June 23, 2003

Ref.: **Docket No. FAA 2003-14715; Notice No. 03-05**

Implications and Impacts of FAA Docket No. FAA-2003-14715: "Noise Limitations for Aircraft Operations in the Vicinity of Grand Canyon National Park; Proposed Rule"

Figure 1. Scaling of NOTAR technology with gross weight.

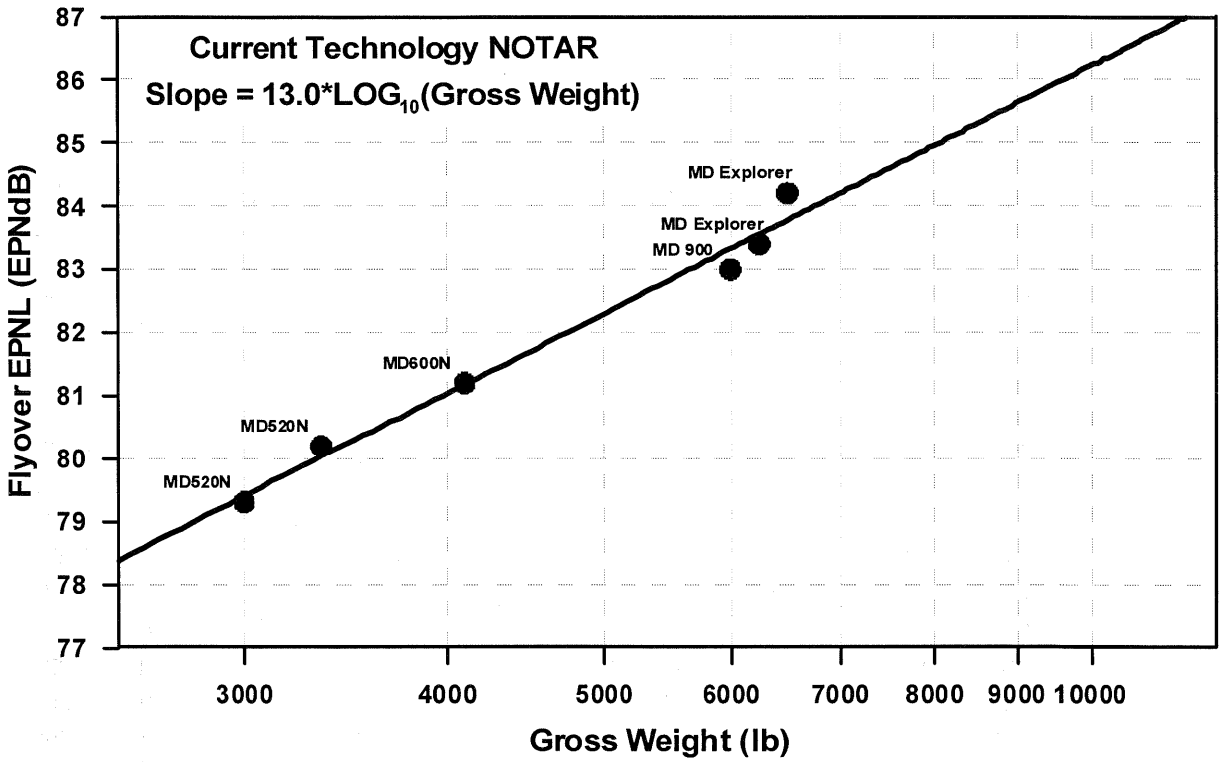
Recommendation 8: For helicopter seating capacities of up to 12 passengers, a more reasonably achievable limit incorporating a slope of *12* Log, rather than the proposed slope of 10 Log should be implemented in the final rule to provide economically and technically achievable limits/incentives for using higher seating capacity helicopters than in current use and provide sufficient room for growth versions of existing quiet designs.

8. The proposed limits will eliminate growth versions of many current helicopters that currently meet the limit (e.g., the EC 135T2 growth version of the EC 135T1). Furthermore, the proposed limits will not only eliminate all recent low noise designs in the intermediate and large categories (e.g., EC155 and EH-101), but also become increasingly difficult to meet by larger helicopters which may in fact adversely impact the intended goal of the "QTD" to foster use of quieter, higher passenger helicopters. These unintended consequences are due to the fact that (1) noise levels of current quiet technologies increase at a rate faster than the 10 Log line when scaled to higher gross weights, and (2) noise levels of growth versions of helicopters increase due to the incorporation of new capabilities, which result in a weight increase or a rotor modification (normally without an increase in passenger seats). The proposed rule therefore contradicts the intent of the National Parks Air Tour Management Act of 2000, which requires the FAA to define quiet aircraft technology requirements for helicopters that is reasonably achievable in order to further restore natural quiet. A more reasonably achievable goal would be to use an equation that incorporates a slope of ***12*** Log, rather than the proposed slope of 10 Log for helicopter seating capacities of up to 12. A slope of ***12*** Log for seating capacities of 12 or less will include one or two additional helicopter models, which will not substantially change the number of current designs designated as quiet technology aircraft while providing economically and technically reasonable and achievable goals for future designs. It is a reasonable compromise between the 10 Log slope proposed in the SNPRM and the 13 to 17 Log slope demonstrated by current technology (as highlighted in Figures 1 and 2).

Table 1. Comparison of Margins to 14 CFR Part 36 Limits – Helicopters Certificated to Appendix H

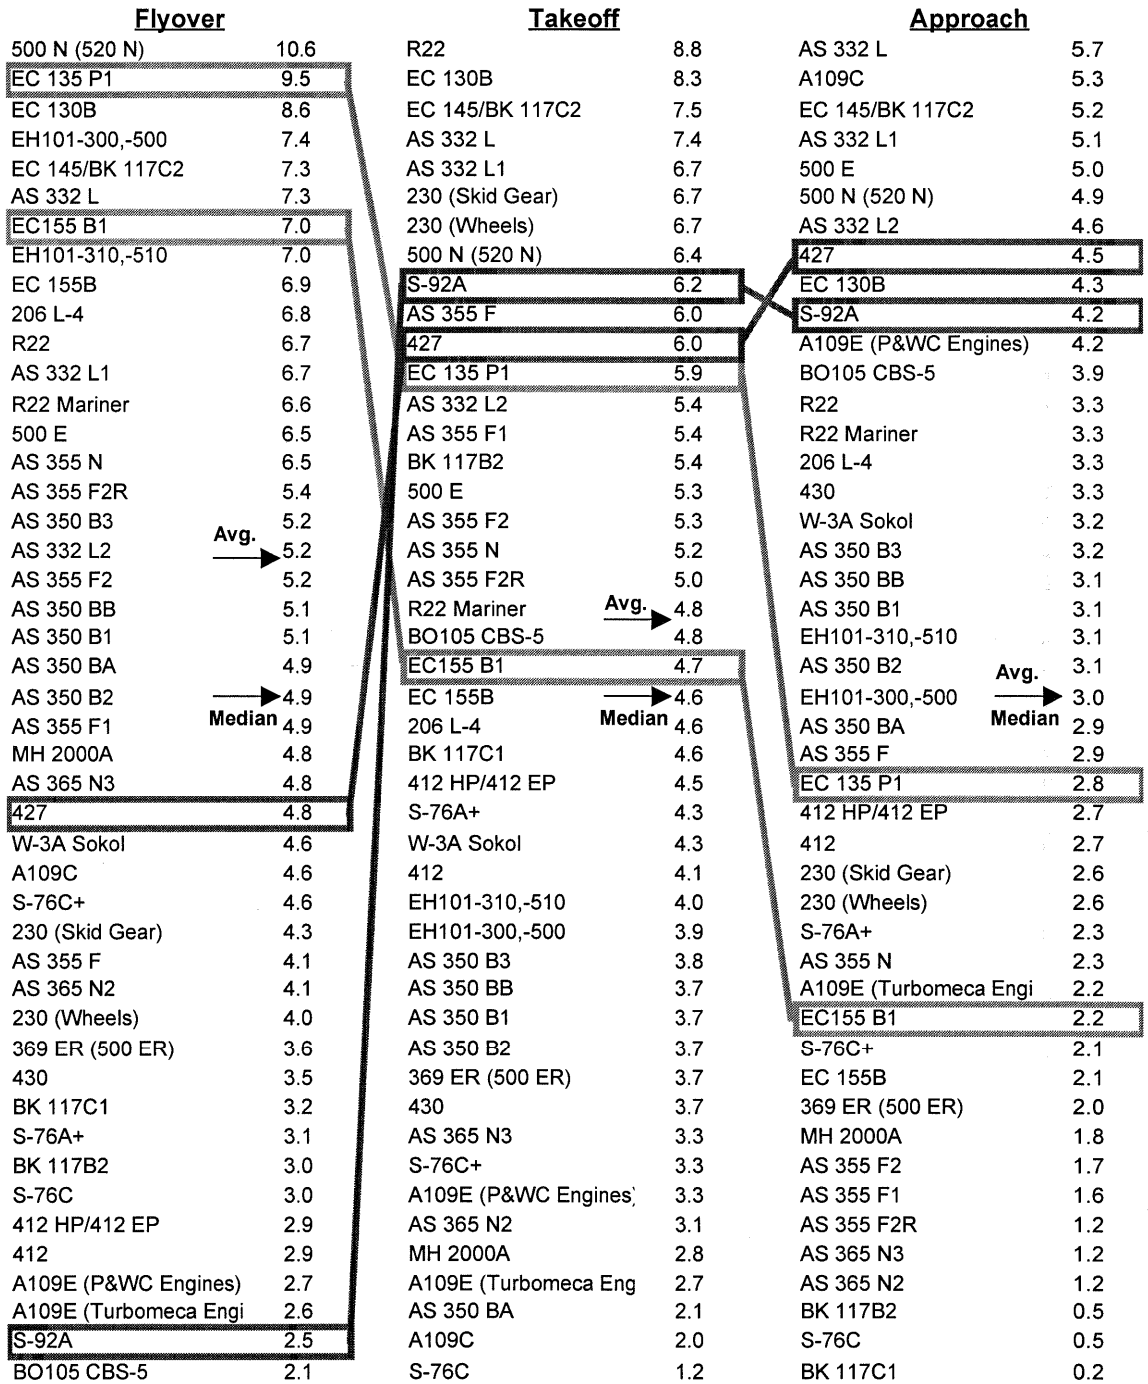
In addition to the adverse performance and cost implications often inherent to "quiet" designs, design requirements and features can lead to tradeoffs between noise levels emitted in different flight operations. This is illustrated in Table 1, which shows the margins to FAR Part 36 Appendix H limits for noise-certificated helicopters. The EC 135 P1 and EC 155 B1, which

incorporate quiet fenestron technology, exhibit an exceptional flyover noise level (high margin) but significantly lower takeoff and approach margins. Conversely, the S-92A and Bell 427, which incorporate low takeoff and approach noise design features, has a relatively higher flyover noise level (a lower margin) but superior takeoff and approach noise margins. These two aircraft illustrate the potential adverse impacts of broader application of the "QTD" beyond GCNP, i.e., both the penalization of helicopters with quiet characteristics in other flight conditions and the potential for takeoff and approach noise levels to be sacrificed in attaining low flyover noise levels for modified or future designs. Also note that the low noise technologies implemented to date, mostly low noise anti-torque (tail rotor) technologies, have primarily benefited flyover noise only as demonstrated by the differences between average and median margins for each flight condition in Table 1. The "QTD" as defined will further skew helicopter noise reduction technology to flyover noise reductions at the expense of noise reduction technology development for the approach and takeoff flight conditions.
